RESPONSE TO IPC QUESTIONS

Glendell Continued Operations Project

Project Director: David Holmes
Project Manager: Bridie McWhirter
Report No. 4166/R31
Date: March 2022

Figure 2.2 Boreholes specifically drilled to inform the development of the gas reservoir model for the Glendell Continued Operation Project

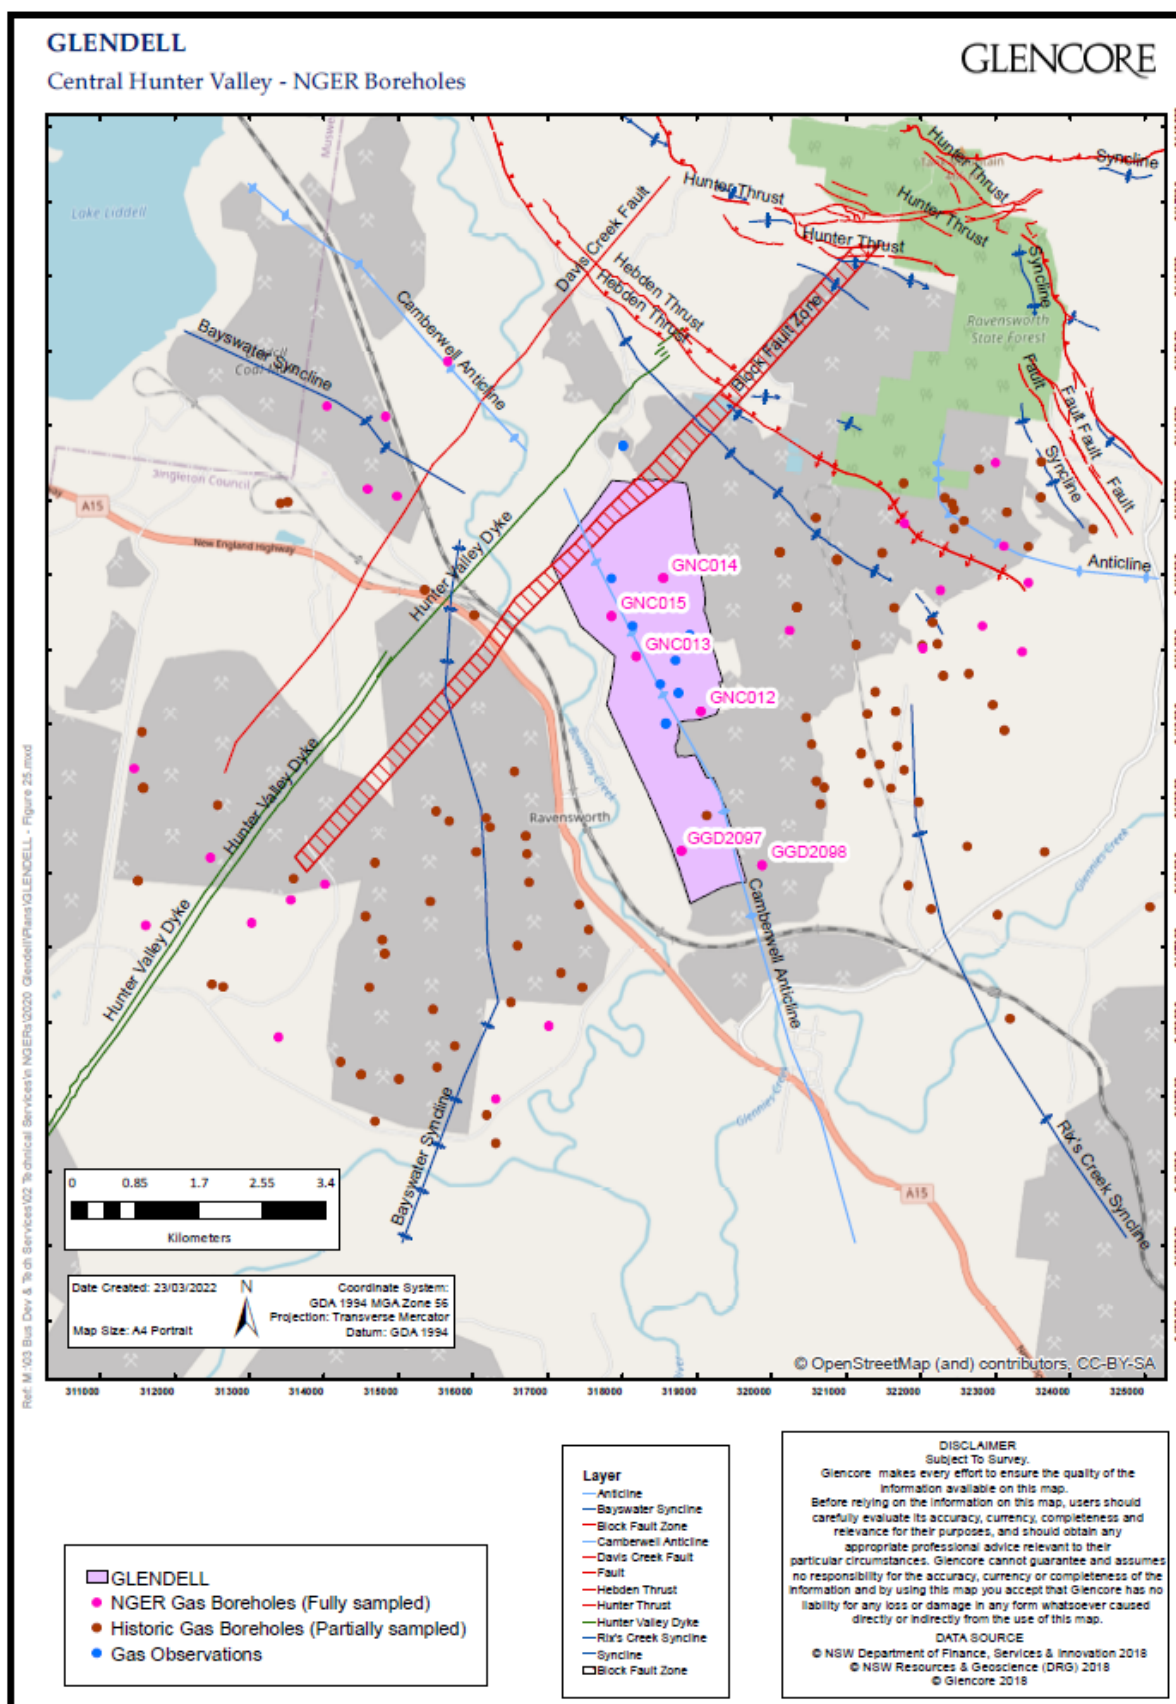
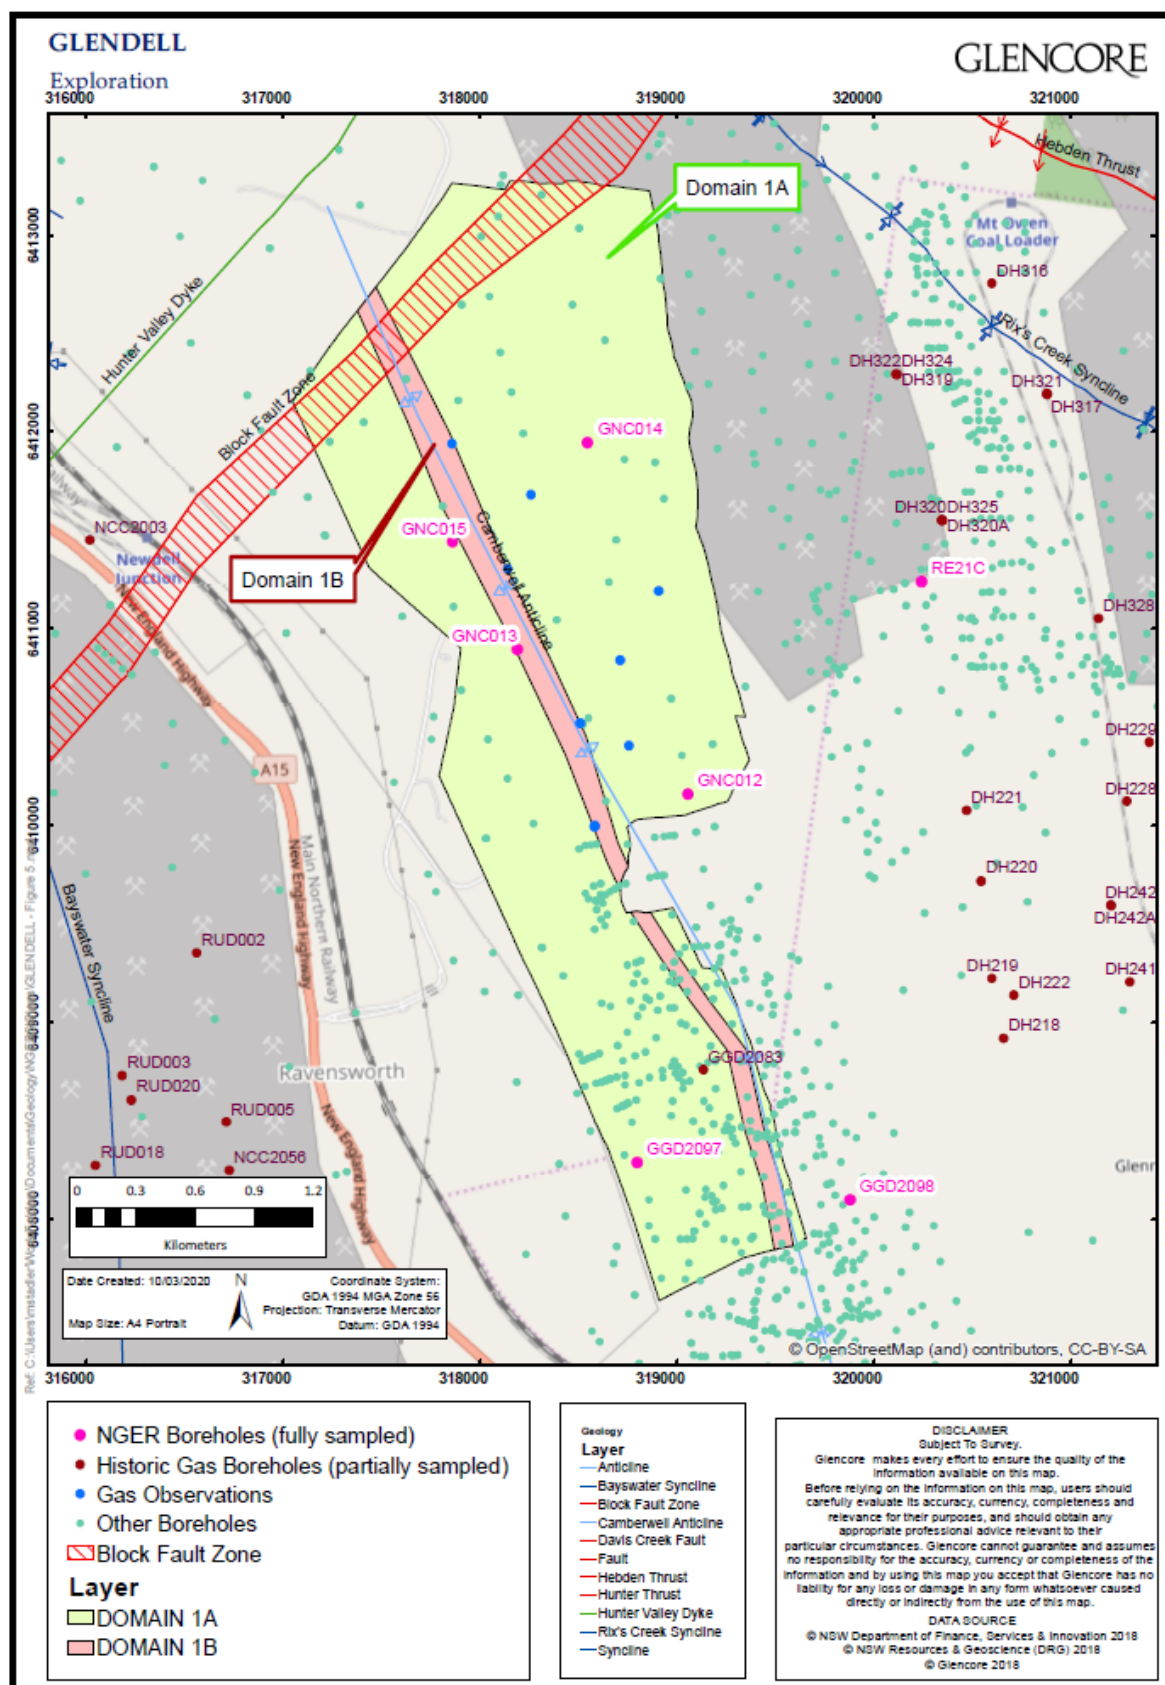
2) Please provide information regarding the bore hole testing that informed the Gas Domain Model (including whether the bore hole testing penetrated all coal seams to be mined, a map showing the bore hole locations and the bore hole data).

Figure 2.1 below shows the location of regional drilling undertaken to inform Method 2 NGERS gas assessments for different Glencore operations in the Ravensworth area. Figure 2.2 shows the boreholes specifically drilled to inform the development of the gas reservoir model for the Glendell Continued Operation Project. Further details for the bores are contained in Table 2.2. All boreholes were drilled targeting the full coal sequence through to the basal Hebden seam (approx. 170-230m depth) and covering the strata 20m below the proposed pit floor as required by Section 3.22 of the NGER Determination. One borehole (Borehole GN013) had to be abandoned around 100m due to adverse drilling conditions and therefore didn't obtain data from all targeted seams. This borehole was redrilled as GN015 further north in a location that was interpreted to exhibit similar geological and gas characteristics. Data collected from both of these boreholes as well as the other drilled were used in the gas domain analysis.

Figure 2.5 Forecast water level and TDS in approved and proposed final void

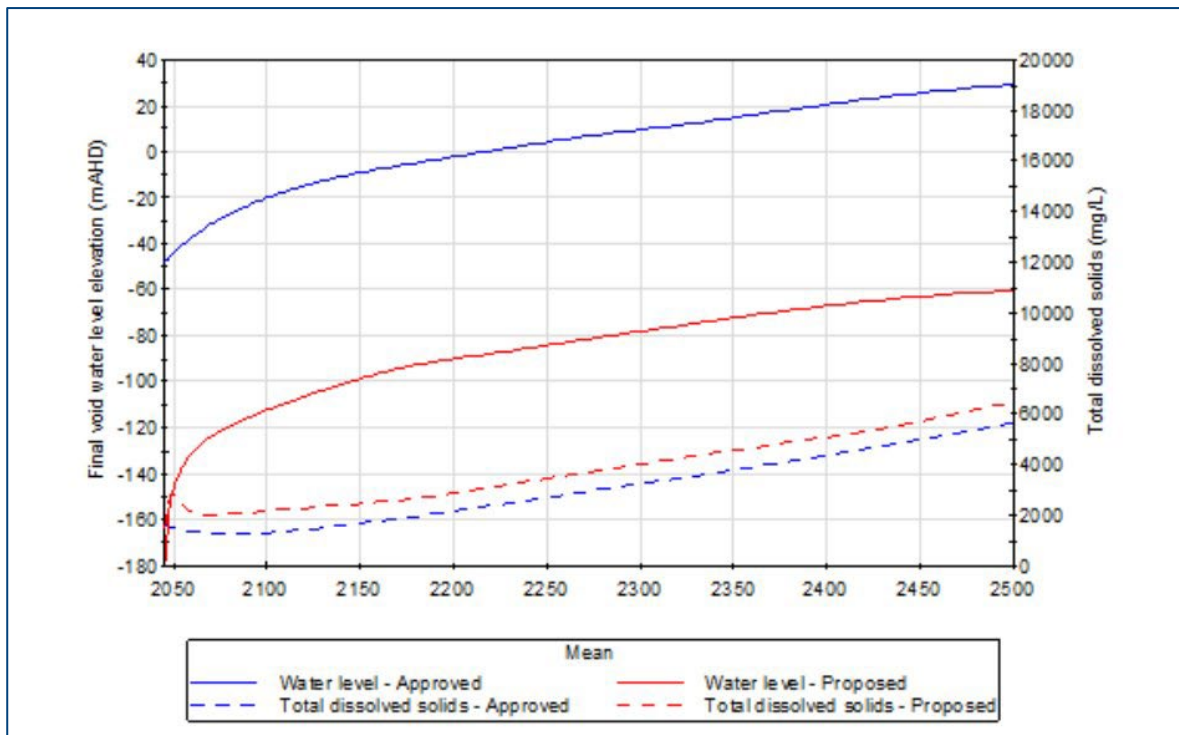
3) At the meeting, the Applicant advised there is no proposal to seal the coal seams in the final void because the seams are largely pre-drained due to the mining history in the local area. Please provide evidence of this and clarification of any other potential options for mitigating the escape of fugitive emissions from the coal seam as part of the mine closure plan.

Coal down dip of the final void that remains fully saturated with groundwater will typically not be able to make further significant emissions as water pressure will retain the natural seam gas within the matrix where it is greater than the desorption pressure. Where the pit is backfilled with dumped spoil the emission rates would be expected to be lower than in places where the seams remain exposed. Emissions from 'exposed' seams in the pit walls in Zones 2 and 3 would be reduced and eventually nullified as the final void is filled with water and the water table within the spoil rises to create a hydraulic head that would retain the gas within the coal matrix. As Zones 2 and 3 occur in the lower sections of the pit shell (refer to Figure 2.5), the pit lake and saturated areas within the spoil will cover these exposed deeper seams earlier (particularly along the eastern side of the Camberwell Anticline hinge) and raise the water table within the surrounding strata, significantly limiting or precluding ongoing release of fugitive emissions from these zones. As shown in the cross-section Figures 2.2 to 2.5 in the Response to the Independent Expert Scientific Committee on Coal Seam Gas and Large Coal Mining Development Advice dated August 2020 (Umwelt 2020a), both the water table and piezometric heads remain elevated in strata immediately surrounding the pit void and these levels recover following the cessation of mining and recovery of water levels in the pit void and spoil (refer to Figure 2.6 to Figure 2.10).

Figure 2.11 Proposed Final Conceptual Landform

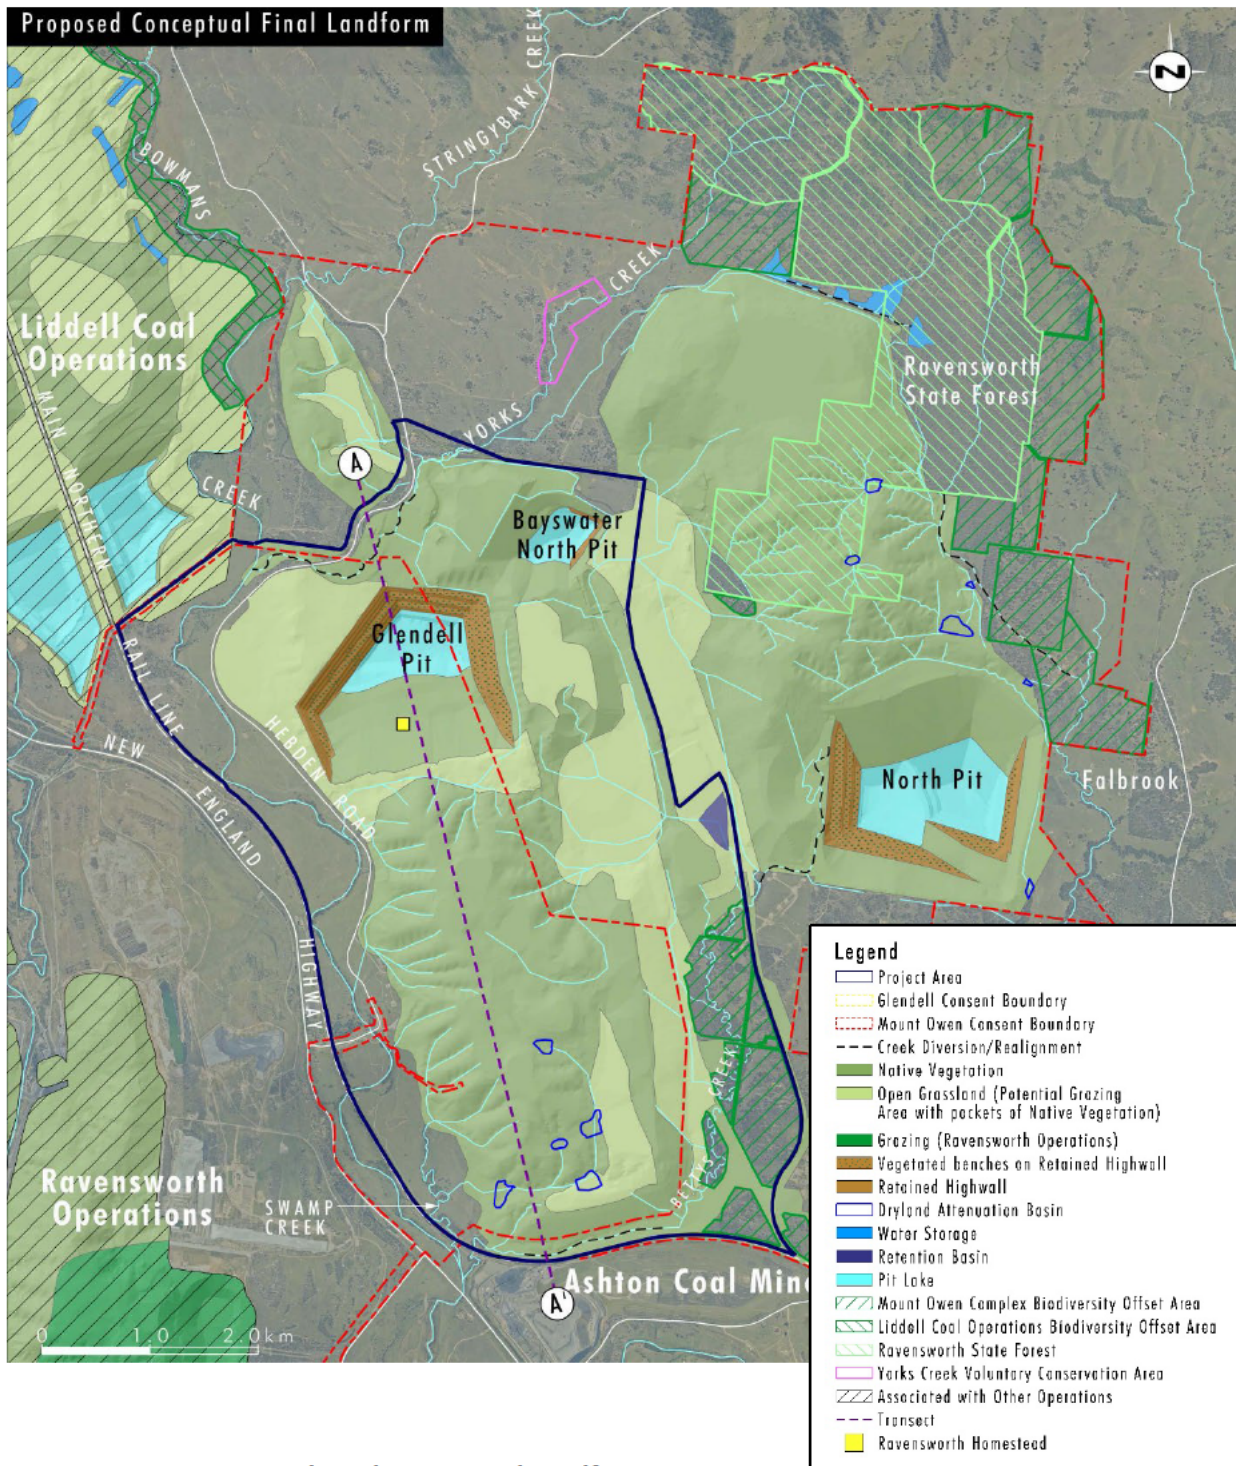
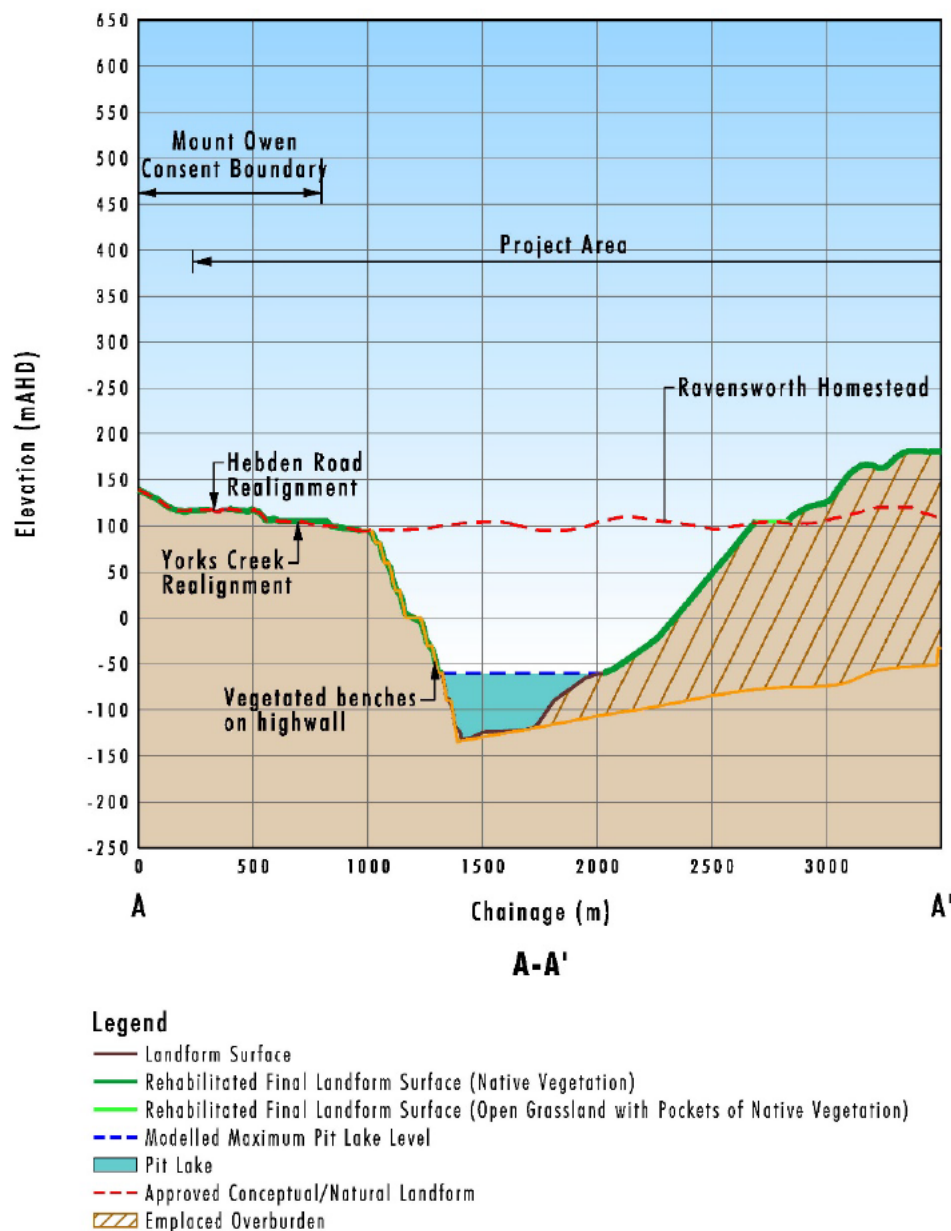
5) At the meeting, the Applicant described that relocating the Ravensworth Homestead back to its original location post-rehabilitation of the site may not be possible because of subsidence issues. Please document this reasoning for the Commission.

The conceptual final landform proposed includes a final void and the existing location of the homestead is located within this proposed void area. Figure 2.11 shows the current location of Ravensworth Homestead relative to the proposed final void and Figure 2.12 shows a cross section of the conceptual final landform with the existing location of the homestead. Almost complete backfilling of the void would be required to ensure that the heritage value of returning the homestead to its pre-mining location were realised. This would require a rehandle of approximately 255 million cubic metres of overburden with associated environmental impacts (noting that, during peak operations only 60 million cubic metres of overburden material are handled (refer to Figure 3.11 of the EIS)) and an associated delay in progressive rehabilitation and landform establishment in the areas from which this overburden is sourced. The consideration of complete backfilling of the void necessary to realise this reinstatement option is considered in Section 5.4 and 5.5 of the Mine Planning Options Report (Appendix 1 of the EIS).

- The backfilled void would undergo settlement and this settlement (the subsidence issues referred to in the question) would pose potential structural hazards for the buildings once reinstated which is likely to impact structural integrity and affect heritage outcomes.
